# Conceptual Review Agenda

Schedule for 09/09/13 to 09/09/13

**Re:** 405 Linden - Change of Use

**Re:** Ladymoon Dr & Precision Dr - Office

# AVENIR MUSEUM EXPANSION SITE PLAN

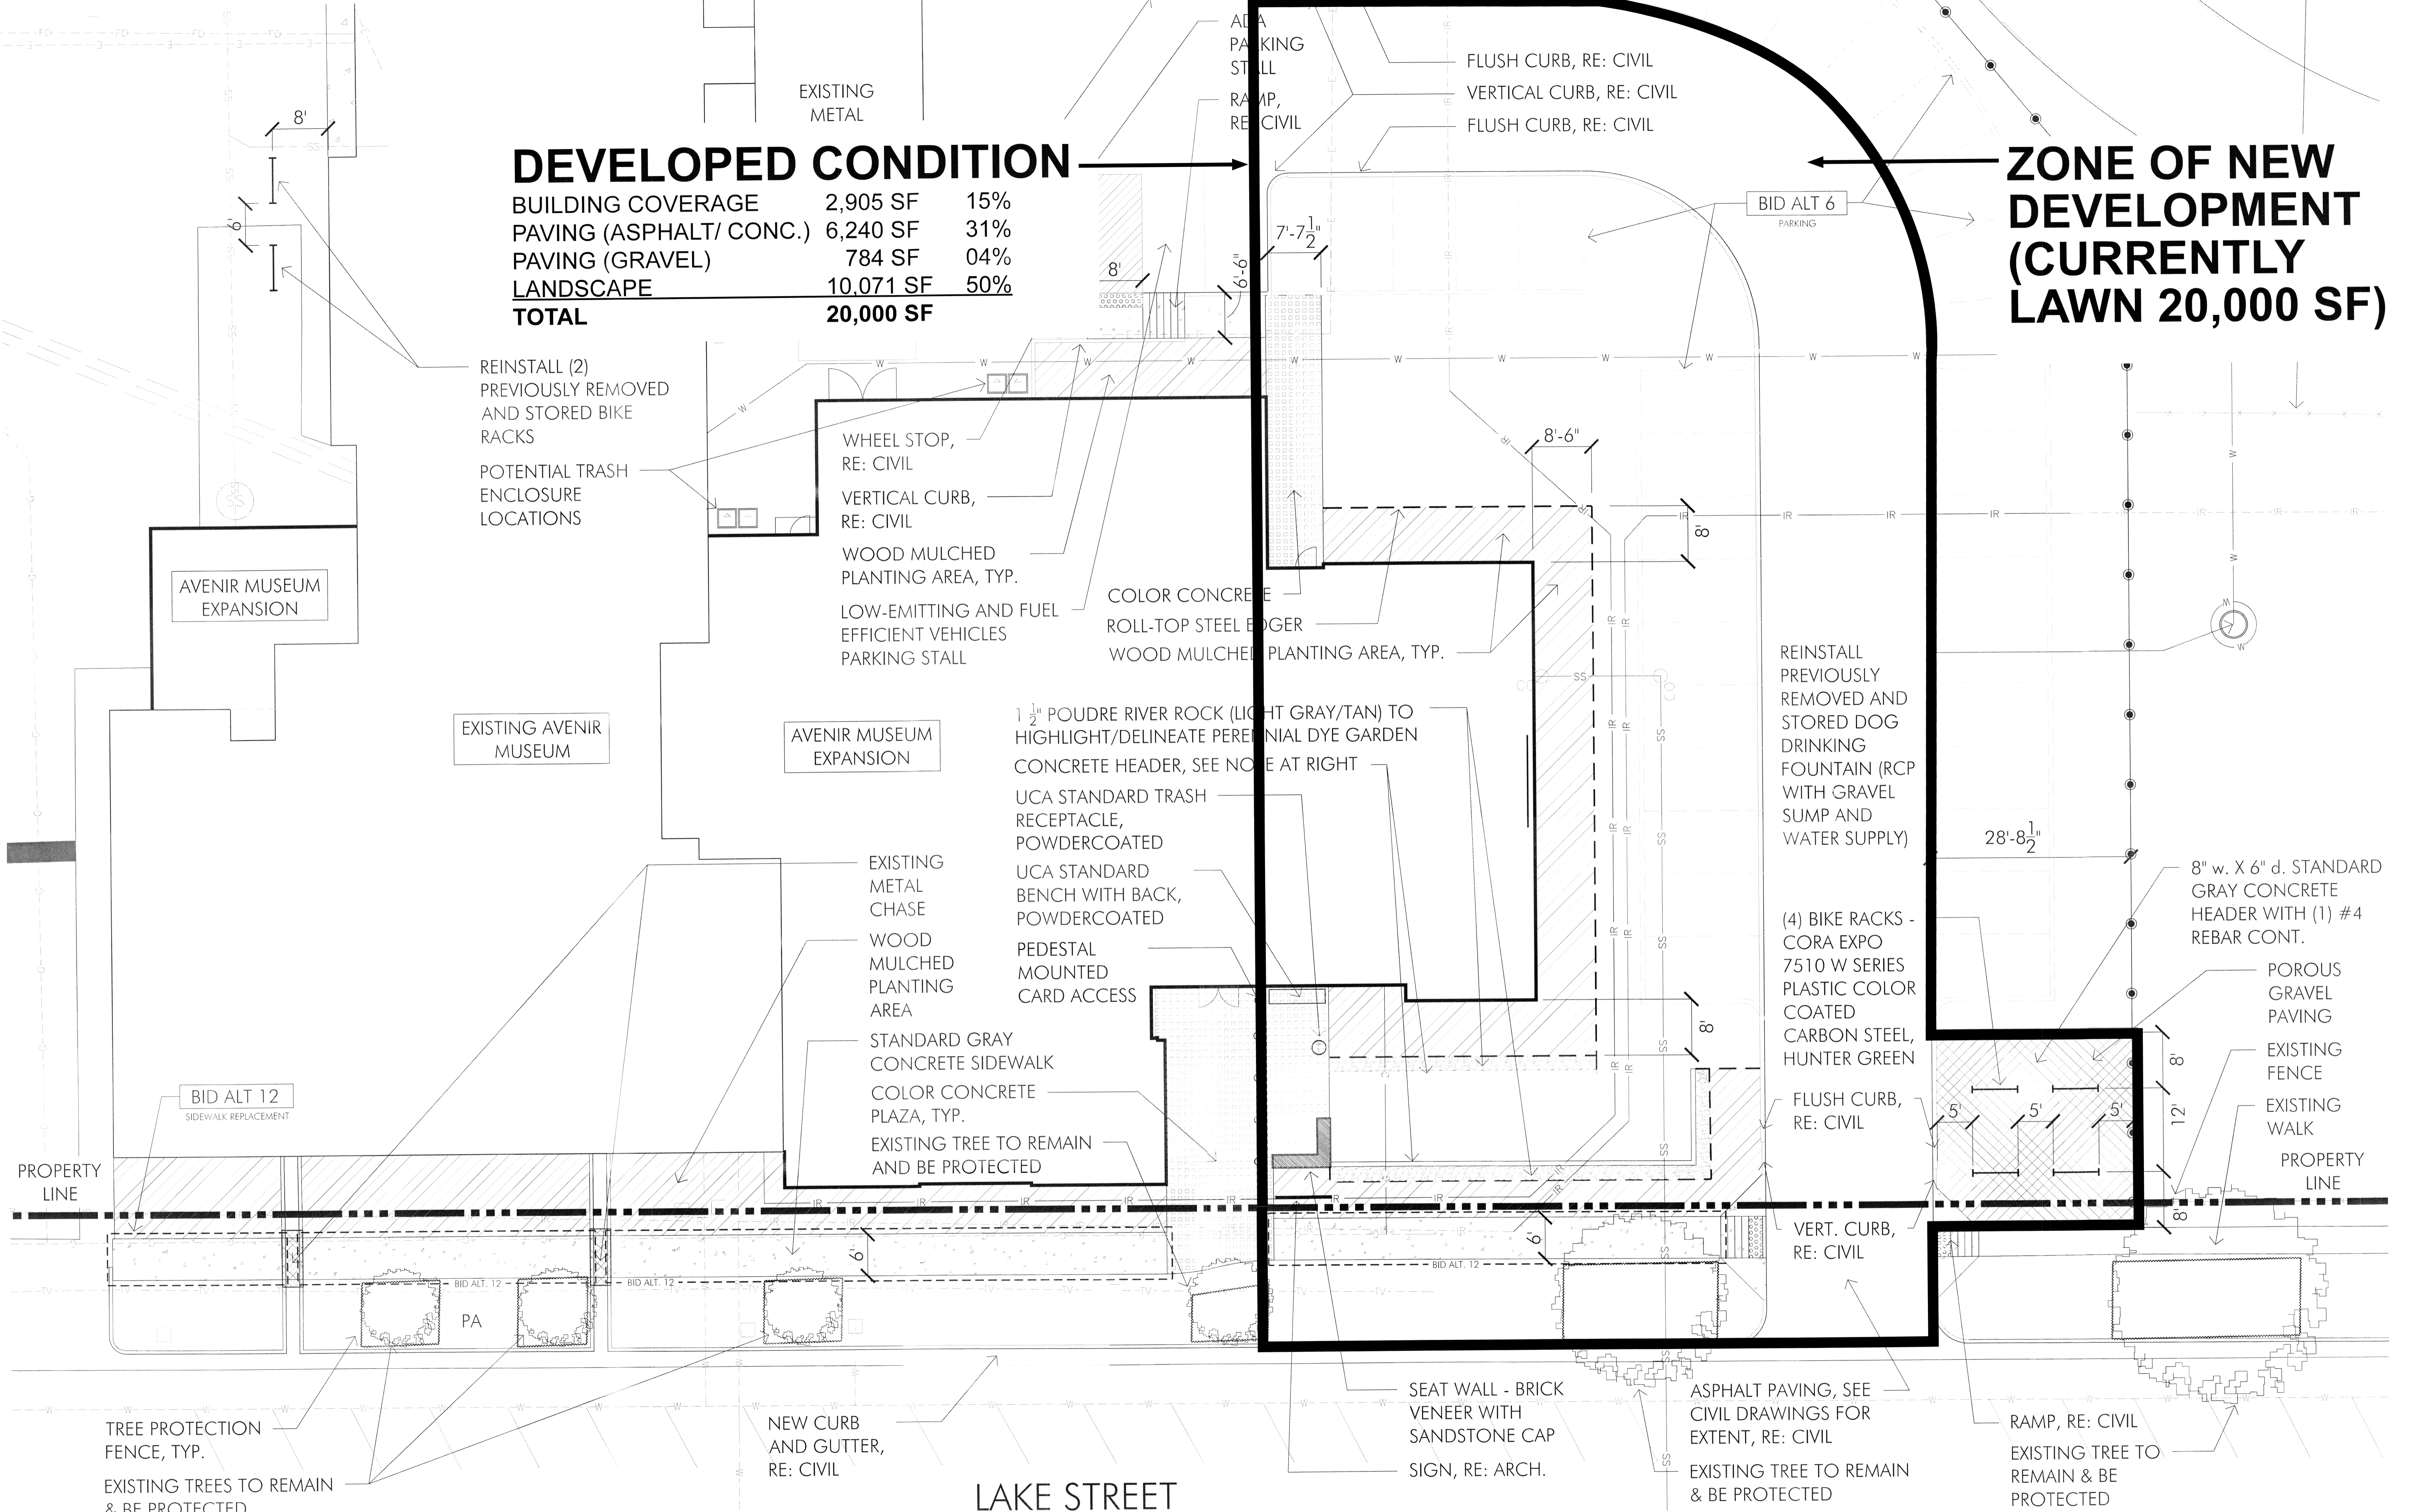
2. If there is an increase in imperviousness greater than 1000 square feet a drainage report, erosion control report and construction plans are required and they must be prepared by a Professional Engineer registered in Colorado. The drainage report must address the four-step process for selecting structural BMPs. Standard operating procedures (SOPs) for all onsite drainage facilities need to be prepared by the drainage engineer. If there is less than 1,000 square feet of new impervious area on an existing development, a drainage letter along with a grading plan should be sufficient to document the existing and proposed drainage patterns. If there is less than 1,000 but more than 350 square feet of new impervious area; a site grading and erosion control plan is required instead of a complete construction plan set.

3. When improvements are proposed to an existing developed site and there is an increase in impervious area greater than 1000 square feet, onsite detention is required with a 2 year historic release rate for water quantity. Parking lot detention for water quantity is allowed as long as it is not deeper than one foot. If there is less than 1000 but more than 350 square feet of new impervious area, a site grading plan is required along with the impervious area documentation.

6. The drainage outfall for the site is either the surrounding streets or there is a storm drain line in Lake St. that would provide a deeper outfall if needed.
